**Issue List for Public Meeting Discussion
Mechanical Engineering Branch (contact: Yiu Law)**

DCD Tier 2, Section 3.9.5

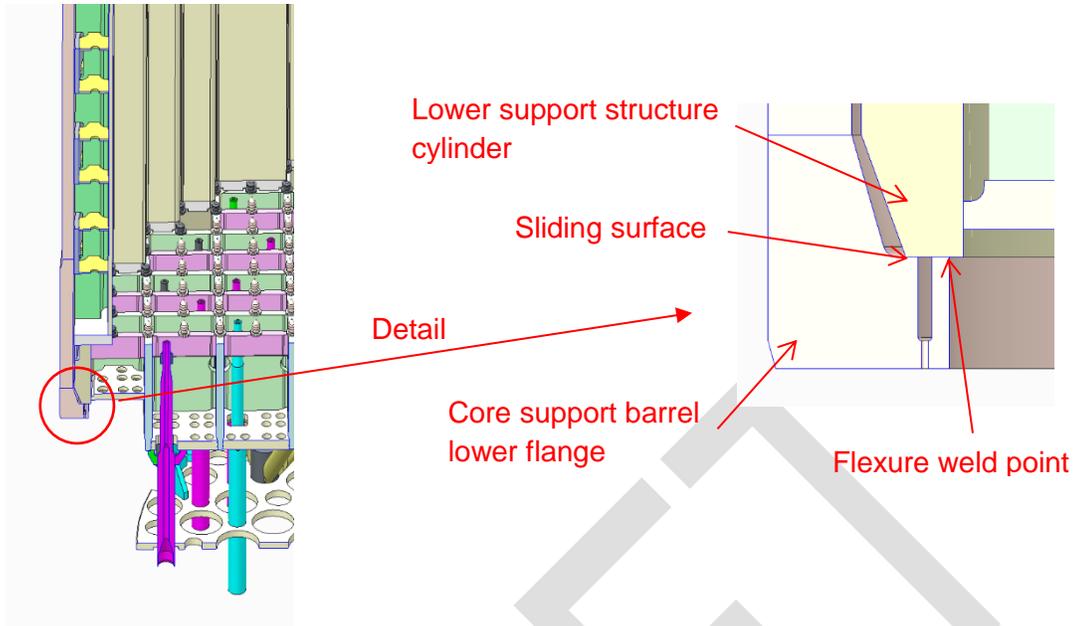
DCD Tier 2, Section 3.9.5.1 states that the hold down spring is classified as an internal structure. DCD Tier 2, Section 3.9.5 states that core support structures are those structures or parts of structures which are designed to provide direct support or restraint of the core within the reactor vessel. DCD Tier 2, Section 3.9.5.1.2 provides a description of the Upper Guide Structure (UGS) assembly and states that the UGS support barrel consists of a right circular cylinder welded to a ring flange at the upper end and to a circular plate at the lower end. It further states that the flange, which is the supporting member for the entire UGS assembly, seats on its upper side against the reactor vessel head during operation. The lower side of the flange is supported by the hold down ring, which rests on the core support barrel upper flange.

Based on the information provided in the DCD, it is unclear why the hold down ring is classified as an internal structure instead of a core support structure, since it provides direct support of the UGS assembly, which is a core support structure according to DCD Tier 2, Section 3.9.5.1. Therefore, the applicant is requested to provide justification of its current classification or revise the DCD to change the classification.

In addition, the applicant is requested to explain the potential loss of preload of the hold down ring due to stress relaxation during all service and accident conditions and its potential effect on the functional and structural integrity of the core support barrel assembly and the upper guide structure assembly.

The hold down ring provides axial force on the flanges of the UGS assembly and the core support barrel assembly in order to prevent movement of the structures under hydraulic forces. The hold down ring is designed to accommodate the differential thermal expansion between the reactor vessel and the reactor internals in the vessel ledge region. The UGS assembly and core support barrel assembly including hold down ring are supported on the reactor vessel ledge. Therefore, the hold down ring is classified as an internal structure since it is not a major component which provides direct support or restraint of the core within the reactor vessel.

Loss of preload may occur due to loss of deflection of the hold down ring as a result of wear on contact surface and stress relaxation during operation. This loss of preload will decrease an axial load on the core support barrel and UGS flange surface and then induce relative motion between the core support barrel and UGS flanges under service and accident loadings. Considering loss of preload, the hold down ring is designed to have enough preload to prevent relative motion of reactor internal components. The function of hold down ring is inspected via CVAP(Comprehensive Vibration Assessment

Program) and the visual inspection results have showed no relative motion of reactor internal components.

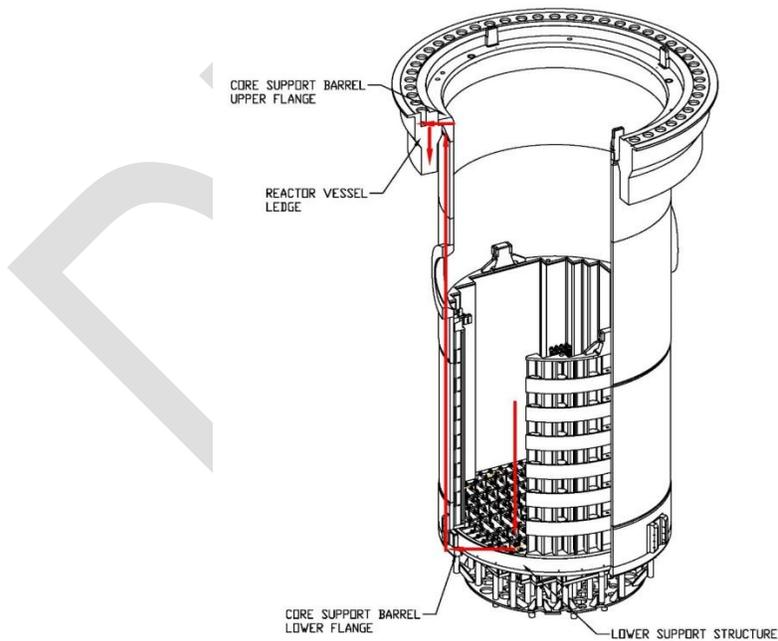
Based on the information provided in DCD Tier 2, Section 3.9.5.1.1 and Figure 3.9-9, it is not clear to the staff the configuration and geometry of either the lower flange of the core support barrel or the core support barrel welded flexural connection to the lower support structure. In addition, DCD Tier 2, Section 3.9.5.1.1 states that the core support barrel assembly is supported at its upper flange on the reactor vessel ledge. However, since the core support barrel lower flange is attached to the lower support structure by means of a welded flexural connection, it is unclear to the staff exactly which component(s) support the weight of the core and how much of the core support barrel and the core is supported at the reactor vessel ledge. DCD Tier 2, Section 3.9.5.1.1 also indicates that the lower support structure assembly is the primary component that supports the weight of the core, and Figure 3.9-8 shows that the lower support structure assembly rests on the clevis at the bottom of the reactor vessel. Therefore, the applicant is requested to provide the above clarification in the form of a more detailed description and drawings.

The configuration and geometry of the core support barrel welded flexural connection to the lower support structure are shown in the following figure. The lower flange of the core support barrel is attached to the lower end of the lower support structure cylinder by a welded flexural connection. The inside part in lower end of the lower support structure cylinder is welded circumferentially to flexure part in the lower flange top of core support barrel. The outside part in lower end of the lower support structure cylinder just slides on inside surface in the lower flange top of core support barrel to accommodate the differential thermal expansion between the lower support structure and the core support barrel.

The lower support structure assembly doesn't rest on the clevis at the bottom of the reactor vessel but on the lower flange of the core support barrel as above figure. The lower support structure directly supports the weight of the core and then transmits the load to the core support barrel lower flange. Finally all the loads of the core support barrel assembly and the core are supported at the reactor vessel ledge. Load path is described in the following figure.

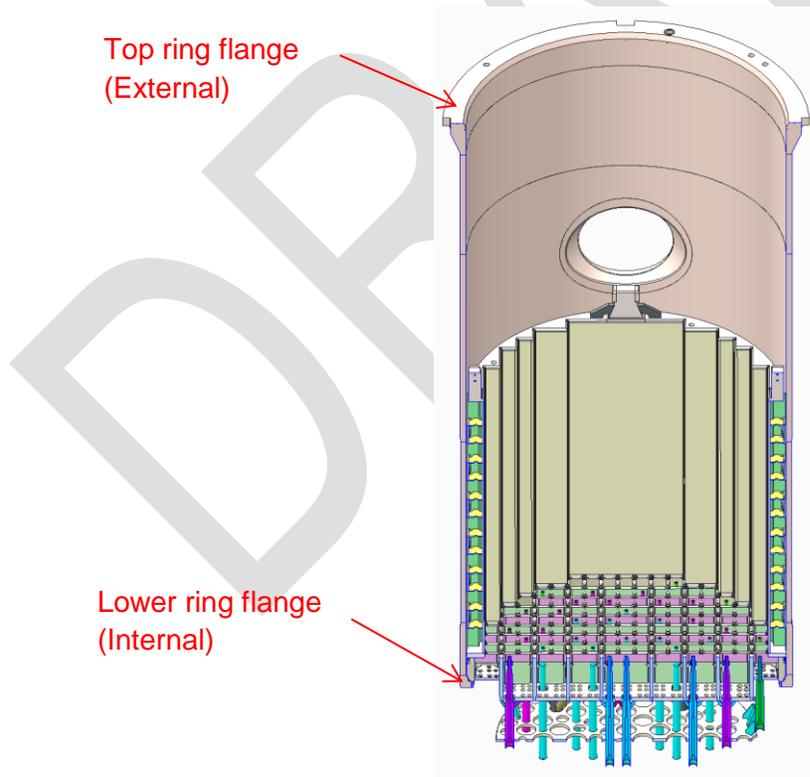
DCD Tier 2, Section 3.9.5.1.1.1 describes the core support barrel as a right circular cylinder including a heavy external ring flange at the top end and an internal ring flange at the lower end. It is unclear to the staff which component is the top ring flange and which component is the lower ring flange in DCD Tier 2, Figure 3.9-9. The applicant is requested to provide a more detailed drawing of the core support barrel that identifies these two ring flanges. In addition, the applicant is requested to describe the function of these two ring flanges and if they support any load during normal and accident conditions.

The configuration related to top and lower ring flange of the core support barrel is shown in the following figure.

The core support barrel assembly is supported at its upper end by the top ring flange of the core support barrel, which rests on a ledge in the reactor vessel. The lower ring flange of the core support barrel supports, secures, and positions the lower support structure including core.

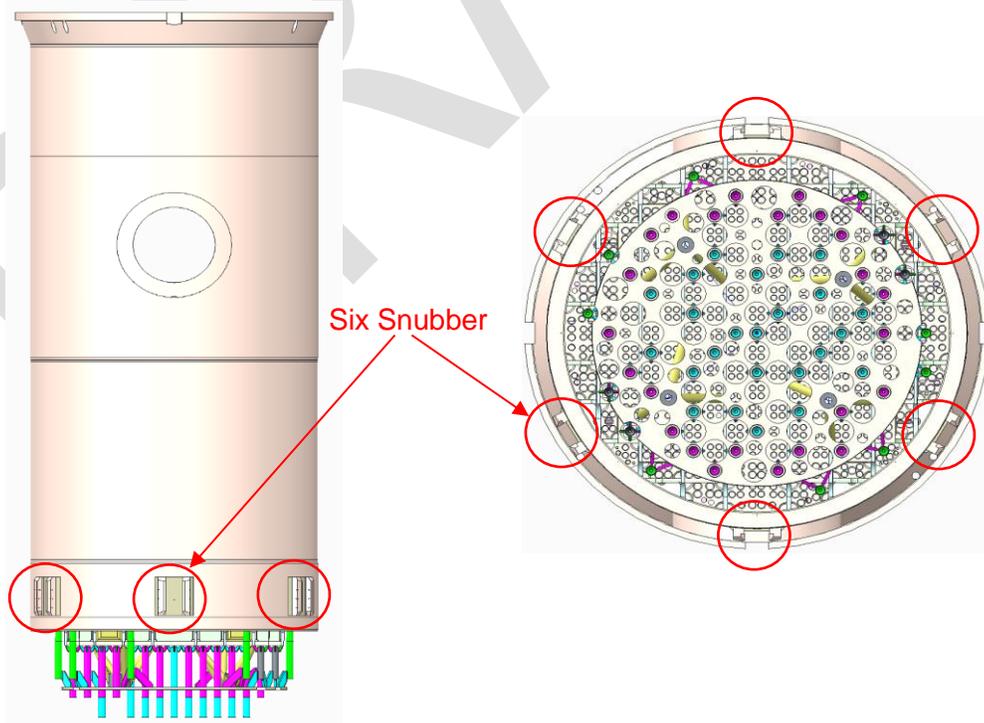
- a. The applicant is requested to explain the flow induced vibration effect on the snubbers under both normal and accident conditions.
- b. The applicant is requested to clarify if the snubber assembly, either the tongue and groove assembly on the core support barrel, or the mating lug on the reactor vessel, support any weight of the core support barrel and the core.

- c. It appears to the staff that there are four snubbers on the core support barrel as shown in DCD Tier 2, Figure 3.9-9, however, DCD Tier 2, Section 3.9.5.1.1.1 states that there are six snubbers. The applicant is requested to clarify this discrepancy.

- d. Figure 3.9-10 shows that four pins and four socket head cap screws are used for assembling the shims to the core stabilizing lug on the reactor vessel. However, no description is provided on how the tongue and groove assembly is attached to the core barrel assembly and how the core stabilizing lug is attached to the reactor vessel. Moreover, no description is provided for the pins and socket head cap screws, how these structural fasteners are classified, and the design code used for the design of these structural fasteners. Therefore, the applicant is requested to provide the information stated above.

- b. The snubber assembly does not support any weight of the core support barrel and the core. Only radial and axial expansions of the core support barrel are accommodated, but excessive lateral and torsional movement of the core support barrel is restricted by six snubbers.
- c. It appears that there are four snubbers on the core support barrel as shown in DCD Tier 2, Figure 3.9-9. But actually core support barrel has six snubbers as shown in the following figure. Left figure is front view of the core support barrel assembly and right figure is bottom view of the core support barrel assembly. Left figure presents only three snubbers. Another three snubbers are located at opposite side.

- d. Core stabilizing lug is attached to the reactor vessel with a full penetration weld. Two core stabilizing shims are assembled with one core stabilizing lug, and four cap screws are used to fasten the shims to the lug. After installing the screws, each cap screw head is line drilled, and one pin and one plug are inserted. The hole where the pin and plug pass through is welded to fix the screw. All parts of the core stabilizing lug are classified and designed as ASME Code Class 1 component (NB), therefore, the structural fasteners are designed by Section III, Subsection NB of the ASME Code.

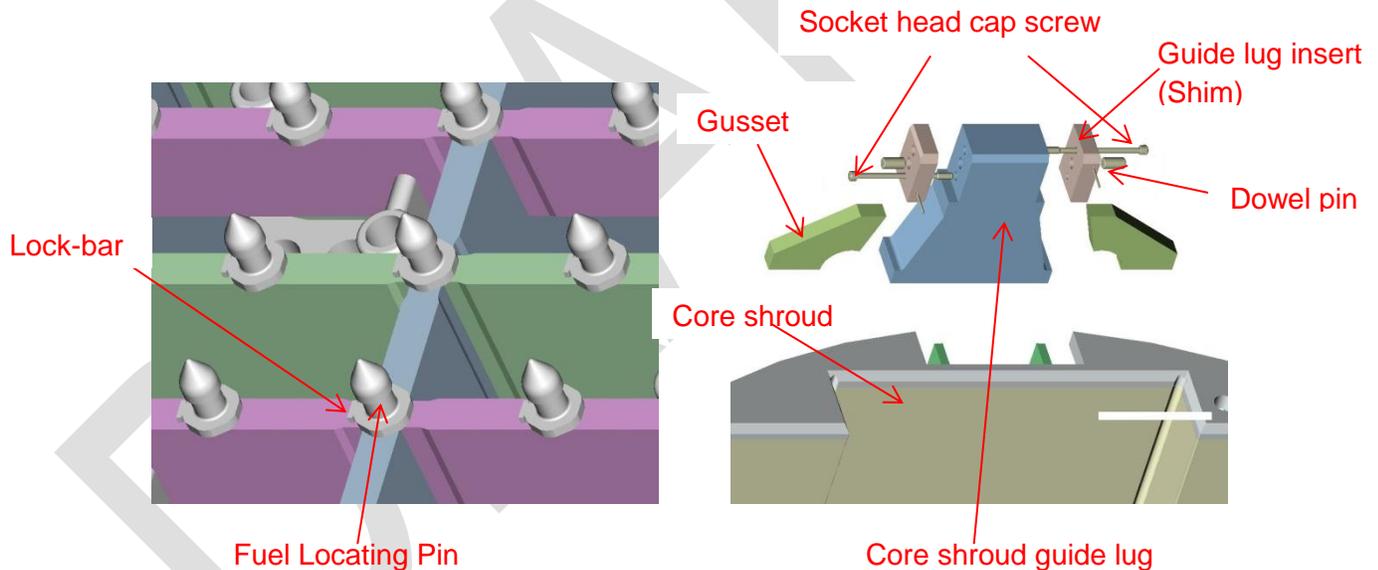
- e. The applicant is requested to clarify if threaded structural fasteners are used in other reactor internals components than those listed in item (d) above.

- e. The fuel locating pins and the socket head cap screws are used as threaded structural fasteners in reactor internal components as shown in the following figure. The fuel locating pins are attached to the top of lower support structure beams to provide orientation for the lower ends of the fuel assemblies. The fuel locating pins are secured as tack weld by lock-bar. The socket head cap screws are used to attach guide lug inserts (shims) to the core shroud guide lug. Four guide lugs, spaced 90 degrees apart, protrude vertically from the top of the core shroud and engage in corresponding slots in the UGS fuel alignment plate to provide proper alignment.

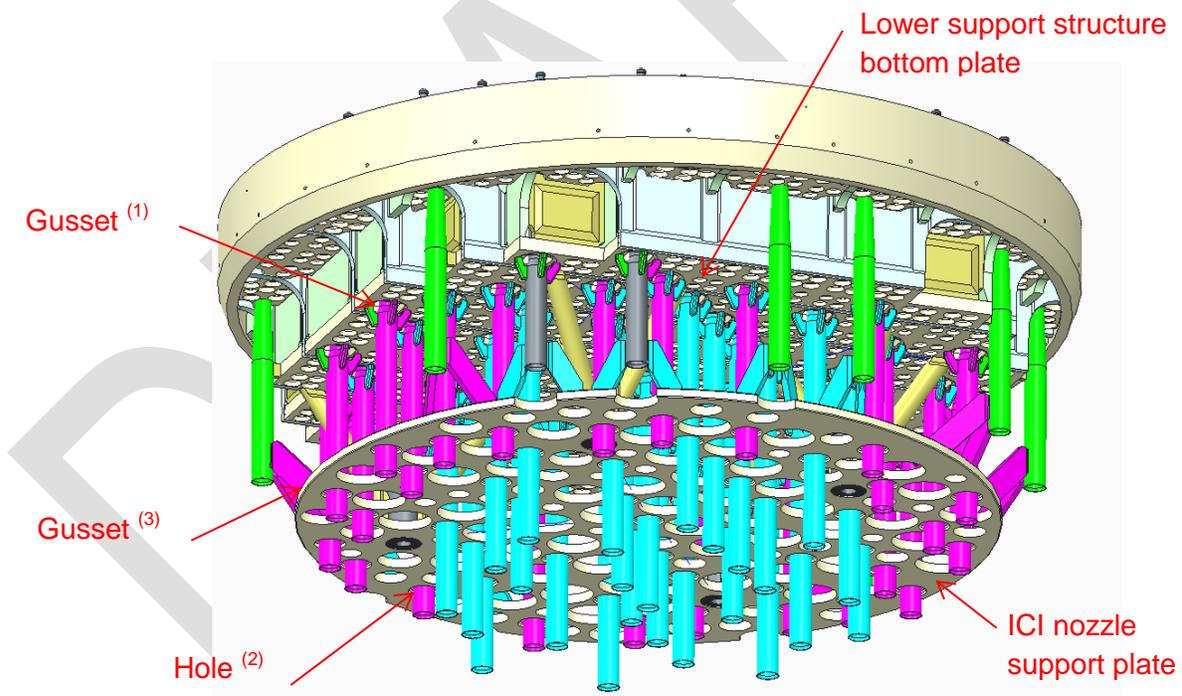
The applicant is requested to further describe and identify, either with additional drawings or in DCD Tier 2, Figure 3.9-11, the aforementioned array of plates that support the ICI nozzles, support columns, and ICI nozzle support plate. In addition, the applicant is requested to describe the following:

The plates of lower support structure consist of bottom plate and raised bottom plate in DCD Tier 2, Figure 3.9-11. Basically the plates contain flow holes to provide a uniform flow distribution at the core inlet and the flow is up through lower support structure plate and then core. The plates are divided into the various flow hole patterns. The patterns are determined by factors such as the ICI locations, the intersection of the support beams with the bottom plate, and the boundary between raised (peripheral) and bottom (central) portions of the plate. The bottom plate is welded to the lower end of main support beam and the raised bottom plate is welded to the beams and the lower portions of lower support structure cylinder.

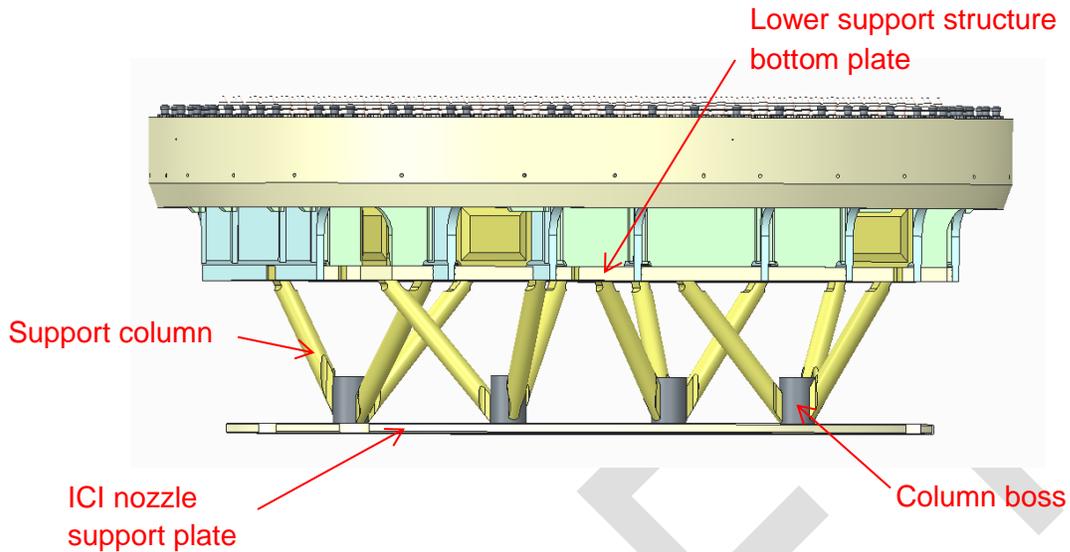
- a. The interface between the ICI nozzle to both bottom plate and ICI nozzle support plate
- b. The location, number, and function of the support columns, and their interfaces to the bottom plate and ICI nozzle support plate as shown in Figure 3.9-11
- c. The function of the gusset as shown in DCD Tier 2, Figure 3.9-11

- a. The upper part of the ICI nozzle is welded to lower support structure bottom plate by gussets⁽¹⁾. The lower part (central) of the ICI nozzle is welded to the hole of ICI nozzle support plate⁽²⁾ and the lower part (peripheral) of the ICI nozzle is welded to ICI nozzle support plate by gussets⁽³⁾ as shown in following figure.

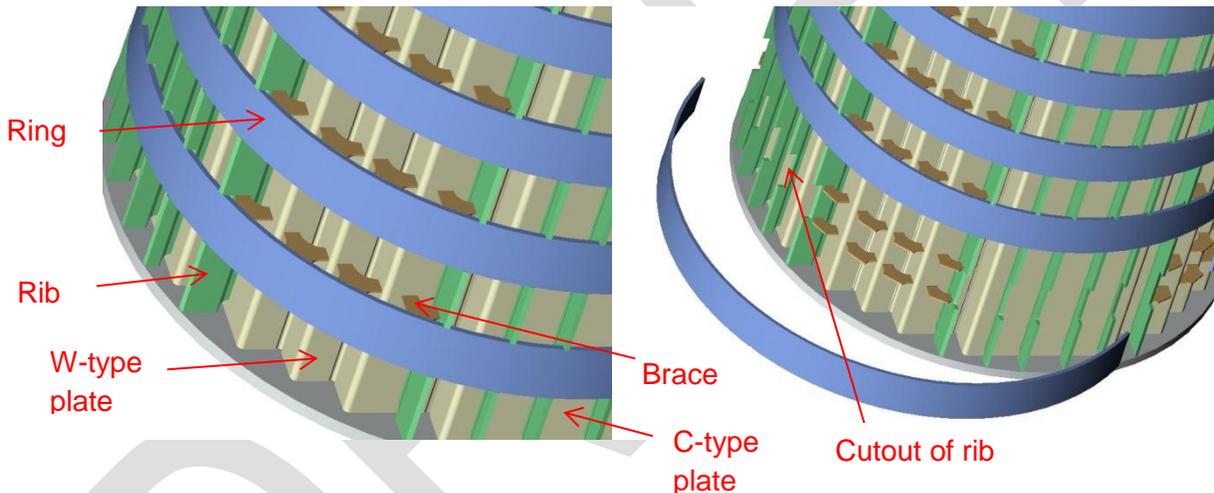
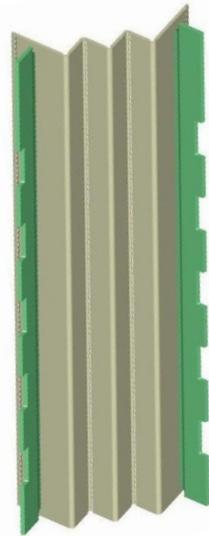
It is unclear to the staff based on this figure how the circumferential rings are attached to the vertical plates by means of full length welded ribs and horizontal braces. Therefore, the applicant is requested to describe how the circumferential rings are attached to the vertical plates. In addition, DCD Tier 2, Section 3.9.5.1.1.3 does not describe how the core shroud vertical plates are attached to each other. Therefore, the applicant is requested to provide this description. If structural fasteners are used, the applicant is requested to provide description on how these fasteners are designed and qualified under the intended operating life of the plant.

The upper and lower portions of the circumferential rings are attached to the cutout of the rib by weld as shown in following figures. The ribs are attached to the vertical plates by means of full length weld axially.

The core shroud vertical plates consist of four W-type plates and four C-type plates as shown in following figures. W-type plate and C-type plate are attached to each other by means of full length weld axially. Therefore the structural fasteners are not used to attach core shroud vertical plates.
